VA Facility CUP

Project No: 607632

Response from Serra Mesa For Planning Commission Hearing

Serra Mesa Community Council

Serra Mesa Map

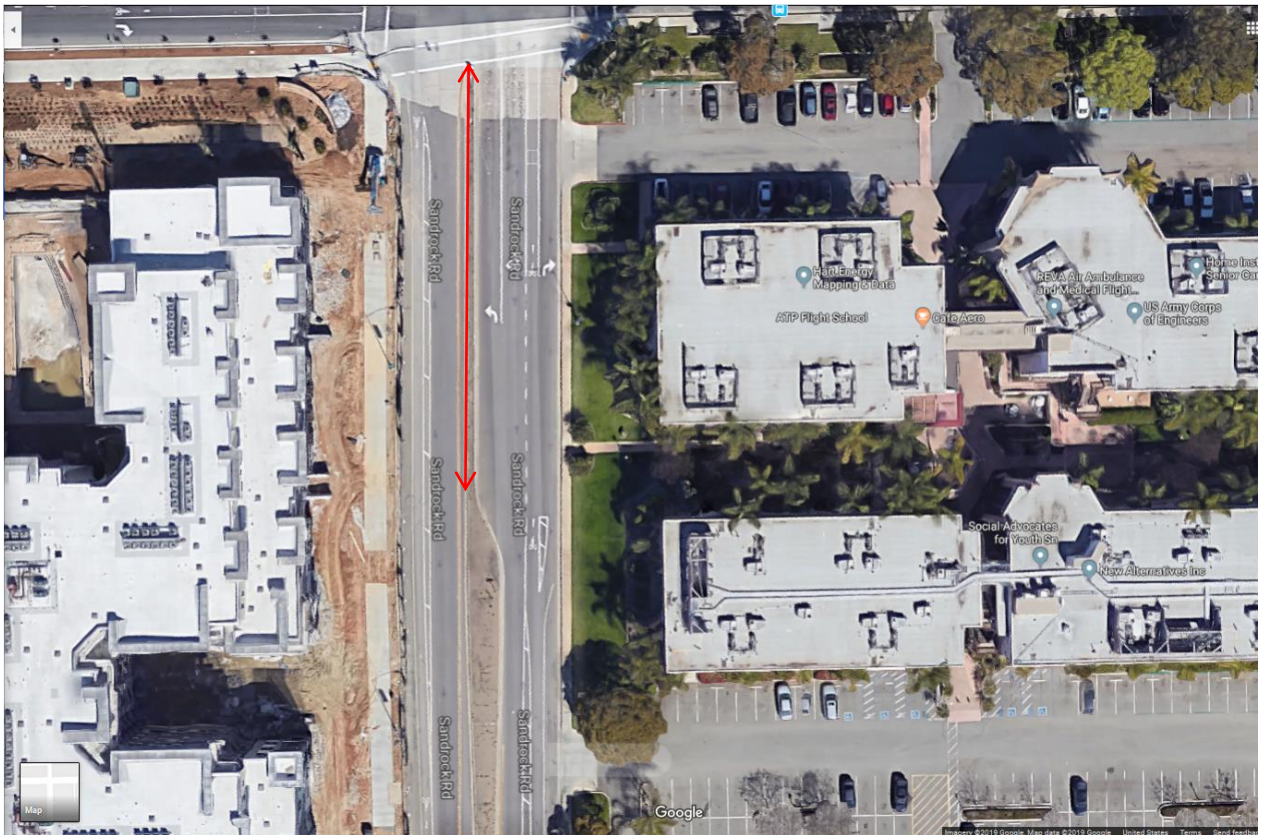
Majority of Sandrock Rd is located in Serra Mesa

Sandrock Road – One lane except for approximately 120ft with 3 lanes; maybe allow queuing of 6 vehicles

Access from Residential Street

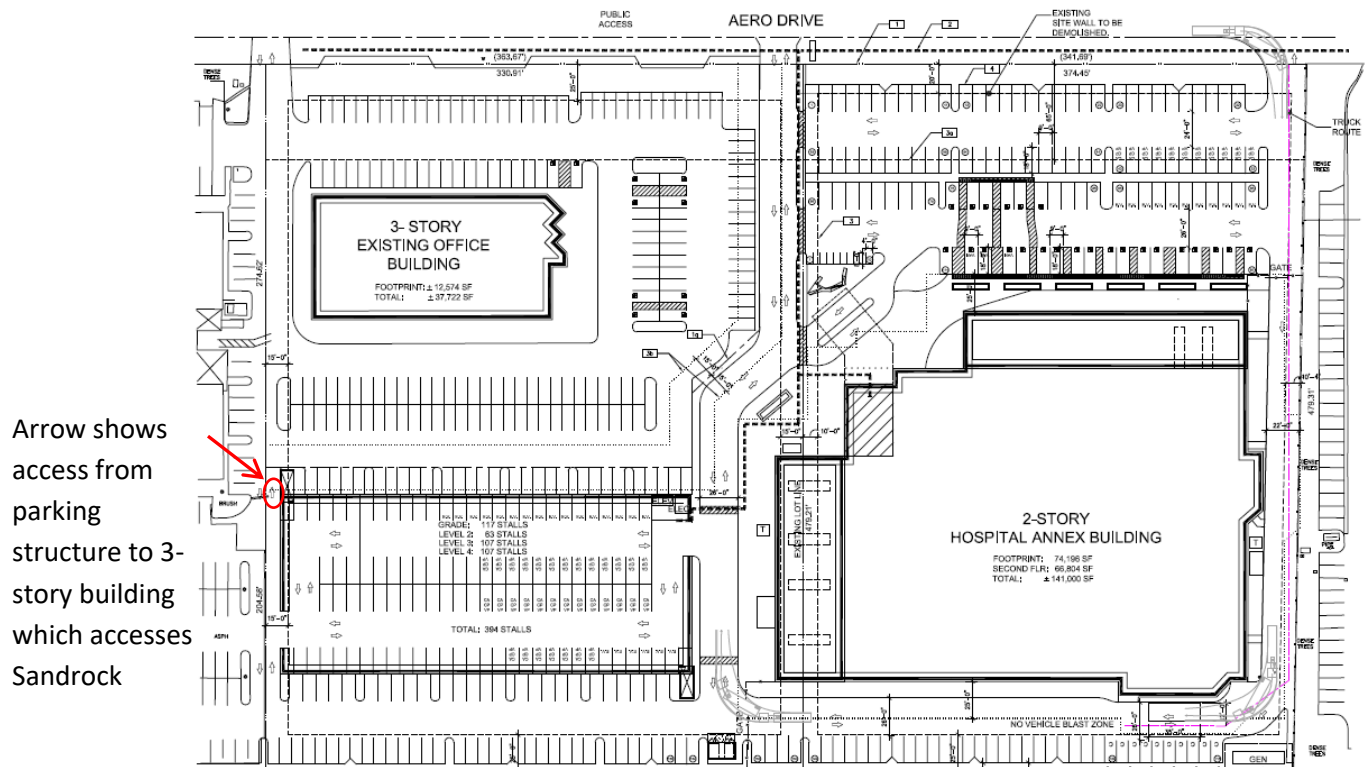
2. Address possible discrepancy in CUP regarding access from Sandrock Road, a residential street, through existing office parking lot to VA project.
3. Address drainage issue at Aero/Sandrock corner.

“Pursuant to LDC §141.0413(d), access to the site shall be as direct as possible from freeways, primary arterials, and major streets and shall avoid residential streets. The proposed project conforms to this provision as access is entirely from Aero Drive and the project site cannot be accessed from residential streets. The Interstate 15, State Route 163, and Interstate 805 freeways all have either direct or nearby connections to access Aero Drive.” (Staff Report, p. 3 of Attachment 4 – Conditional Use Permit)
